DEVELOPMENT ASSESSMENT REPORT	
Application No.	DA/2022/0467
Address	96 Addison Road MARRICKVILLE
Proposal	demolition of existing improvements and construction of a mixed used development containing 2 commercial tenancies and 14 residential units with basement car parking
Date of Lodgement	16 June 2022
Applicant	BENSON MCCORMACK PTY LTD
Owner	CORDARO PTY LTD
Number of Submissions	Initial: 1
Value of works	\$6,766,352.00
Reason for determination at Planning Panel	Section 4.6 variation exceeds 10% SEPP 65
Main Issues	Height of building Massing and setbacks Building Envelope
Recommendation	Approved with Conditions
Attachment A	Recommended conditions of consent
Attachment B	Plans of proposed development
Attachment C	Section 4.6 Exception to Development Standards

This report is an assessment of the application submitted to Council for demolition of existing improvements and construction of a mixed used development containing 2 commercial tenancies and 14 residential units with basement car parking at 96 Addison Road Marrickville.

Figure 4: Rear envelope exceedance of proposed development

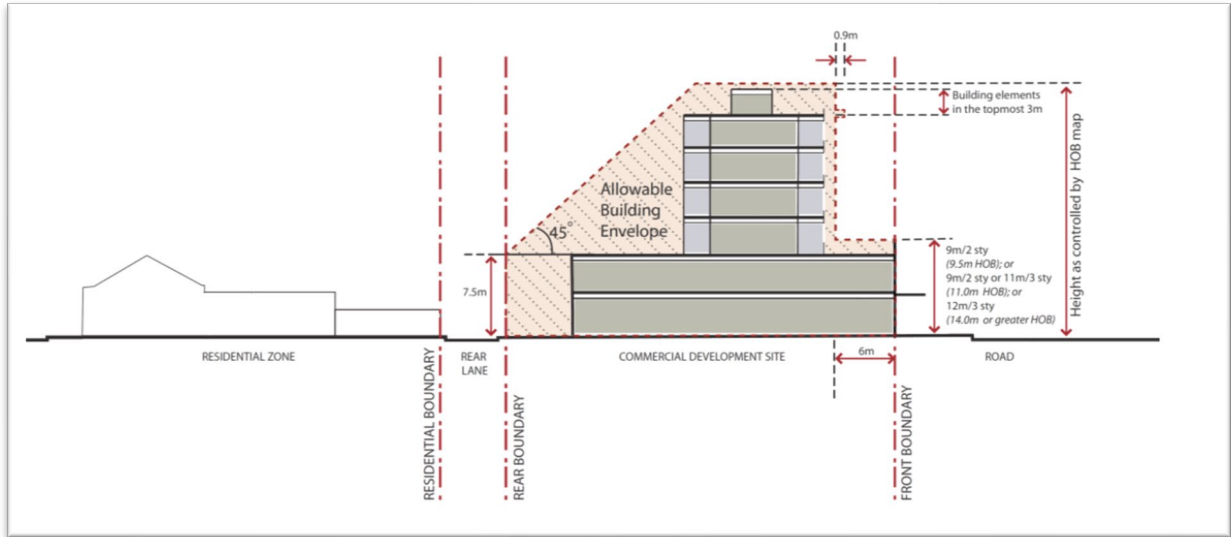
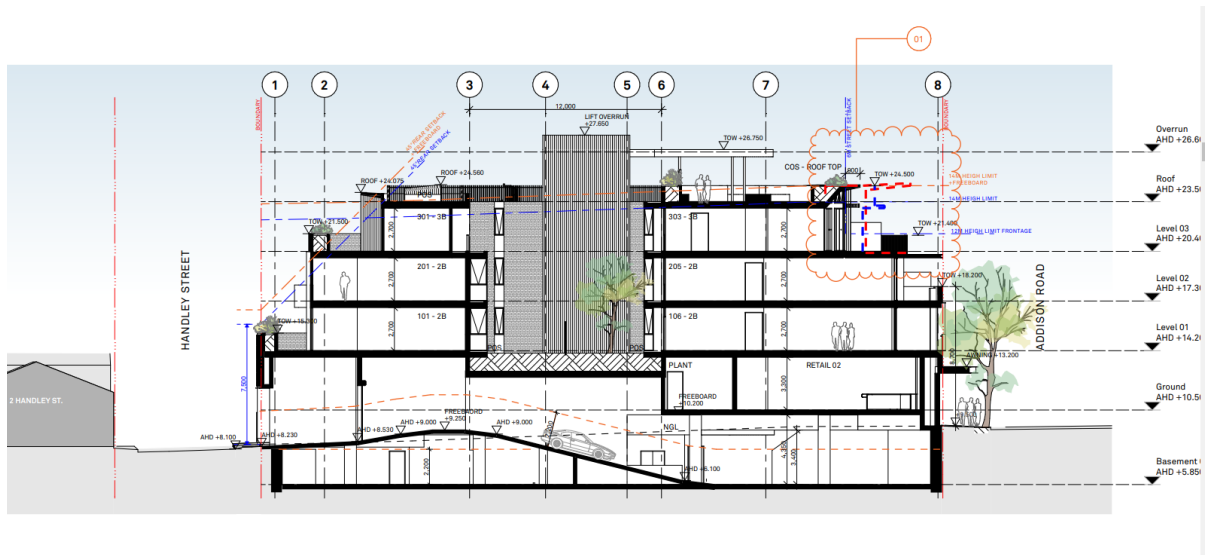
The proposal results in a variation to control C13(i), which requires new developments to contain the rear boundary plane at a 45-degree sloping plane once above a 7.5m point, measured vertically above the ground lane level (Figure 3). The proposal (Figure 4) varies this control for a small section of the development where it relates to the second and third floor units, and balustrading to the roof top terrace.

Notwithstanding the above, the proposal is consistent with control C13(ii), which outlines that development may exceed the in control C13(i) prescribed rear building envelope as the development will not result in undue visual bulk impacts to neighbours.
